INDEPENDENT PLANNING REVIEW—ELECTRANET PRELIMINARY CAPITAL EXPENDITURE PROJECTS

SOUTH AUSTRALIAN ADVISORY FUNCTIONS

September 2016

Figure 1 Single line diagram illustrating the establishment of the Gawler East connection point

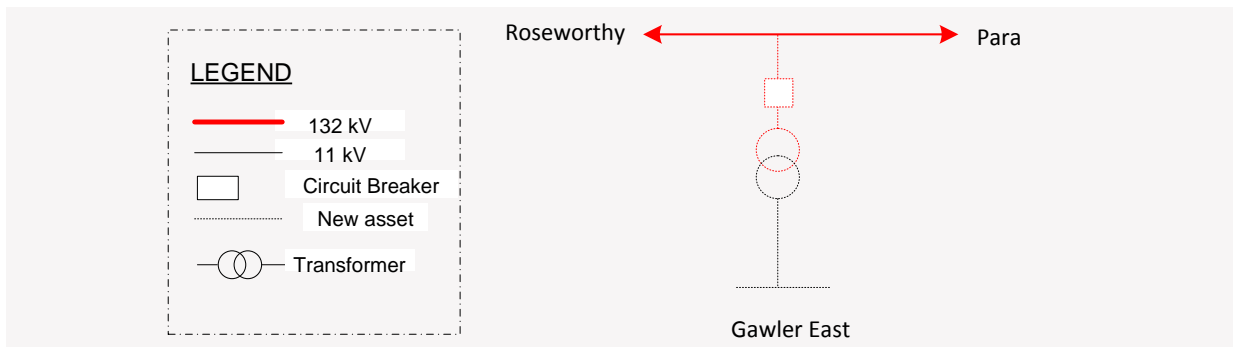
AEMO agrees with ElectraNet that the establishment of a 132 kV connection point at Gawler East is likely to be the most economical solution, but this will be confirmed by a Regulatory Investment Test for Distribution (RIT-D). AEMO understands that SA Power Networks will commence a RIT-D assessment in 2016 to confirm the preferred option.

Because the Gawler East limitation is localised within the distribution network, AEMO's connection point forecasts do not capture the demand growth driving this limitation. At this stage, AEMO considers there is a need for this proposed project if SA Power Networks' demand forecast for Gawler East eventuates, and will provide further review in the Stage 2 assessment when information relating to SA Power Networks' demand forecast becomes available.

Figure 2 Mount Barker and Mount Barker South area supply

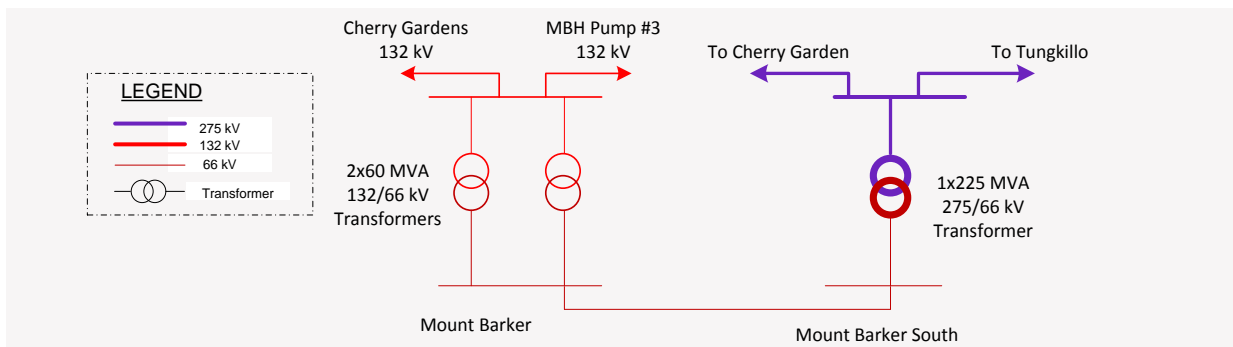
Mount Barker and Mount Barker South are Category 4 connection points under the ETC. Under Category 4 connection reliability requirements, Mount Barker and Mount Barker South must have N-1¹¹ equivalent transmission line and transformer capacity to meet 100% of agreed maximum demand. Retiring poor condition assets at Mount Barker without replacement would lead to non-compliance with ETC requirements.

ElectraNet considered multiple reinvestment options¹² to address the emerging need to manage poor condition assets at Mount Barker. Based on economic analysis carried out to rank the economic efficiency of these options, ElectraNet proposed to refurbish the poor condition assets at Mount Barker substation.

Based on ElectraNet's advice that the existing assets need to be replaced in the next regulatory period, the need to meet ETC reliability requirement, and the economic efficiency of different reinvestment options, AEMO considers ElectraNet's proposal to be appropriate.

Figure 4 Mount Gambier substation supply

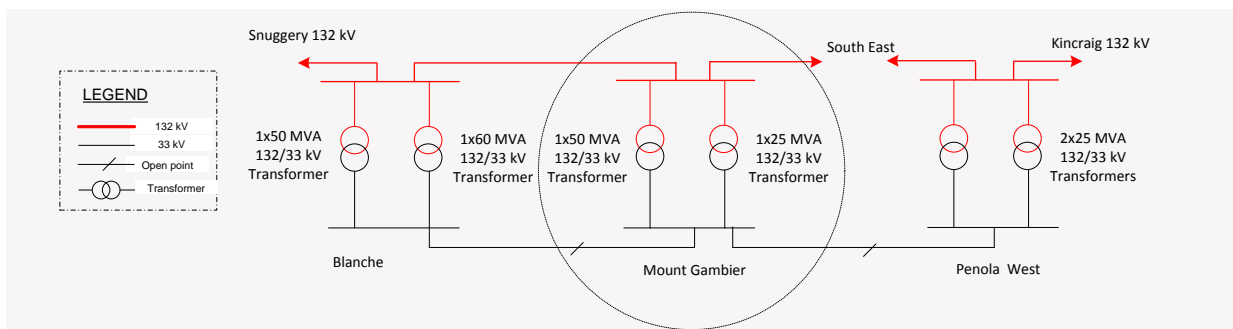
In principle, AEMO considers ElectraNet's proposal to replace the existing 50 MVA transformer at Mount Gambier with a 25 MVA transformer to be reasonable. AEMO assessed the potential scope of

distribution network augmentation required, and agrees with ElectraNet's findings that options to strengthen the 33 kV distribution network are expected to be much more costly than the transformer replacement option.

Based on the need to meet ETC reliability requirement, ElectraNet’s advice that the existing assets need to be replaced in the next regulatory period, and the economic efficiency of different reinvestment options, AEMO considers ElectraNet’s proposal to replace the existing 50 MVA transformer at Mount Gambier with a 25 MVA transformer to be reasonable. However, it is important to note that the AER

Figure 6 Leigh Creek South and Leigh Creek Coal field supply

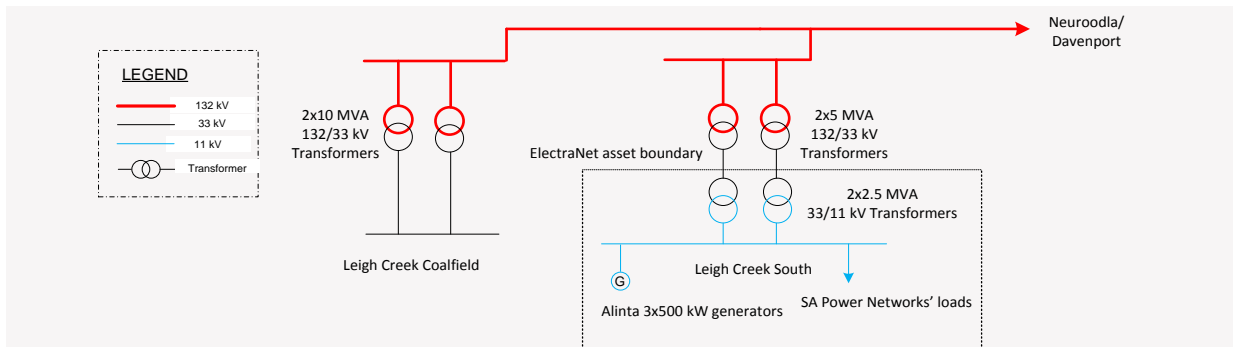
ElectraNet's proposal considers asset condition, demand forecasts, reinvestment efficiencies, and the uncertainty of supply requirement at Leigh Creek South and Leigh Creek Coalfield. Based on the assumed future outlook, AEMO agrees with ElectraNet's recommendation at this stage.

Figure 10 Single line diagram illustrating the addition of a single 275 kV circuit breaker diameter at the existing Robertstown 275/132 kV substation

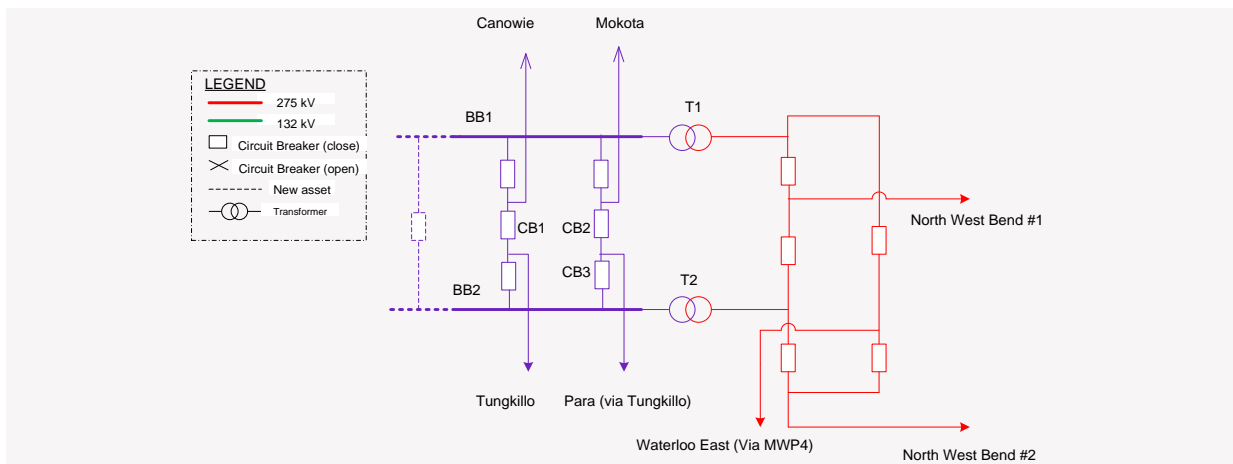
The addition of a circuit breaker at the Robertstown substation (see Figure 10) will address this issue. However, AEMO's economic assessment does not support this expenditure based on ElectraNet's current cost estimates.

Given the operational difficulties that AEMO and ElectraNet have encountered in scheduling maintenance on 275 kV circuit breakers at Robertstown in the past, AEMO will work with ElectraNet to ensure the full range of market benefits are considered during the second stage assessment.

Figure 12 Single line diagram illustrating addition of a 132 kV circuit breaker at Blanche substation

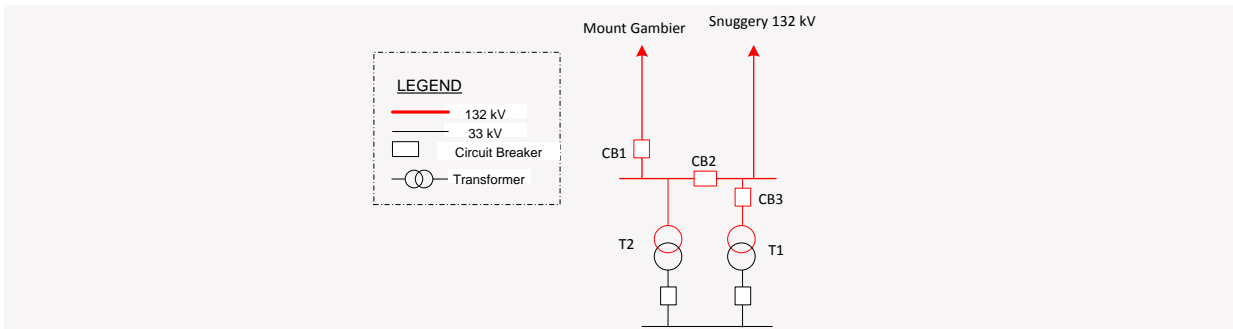
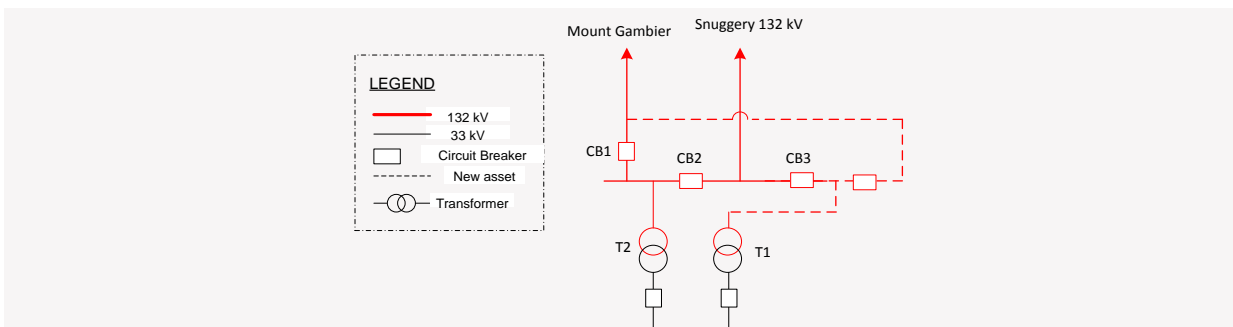
Planned outages at the Blanche 132 kV substation are operationally difficult to schedule, as they might constrain generation connected at Snuggery²⁰ and expose customers to a risk of supply interruption. ElectraNet proposes to install an additional 132 kV circuit breaker and create a meshed substation
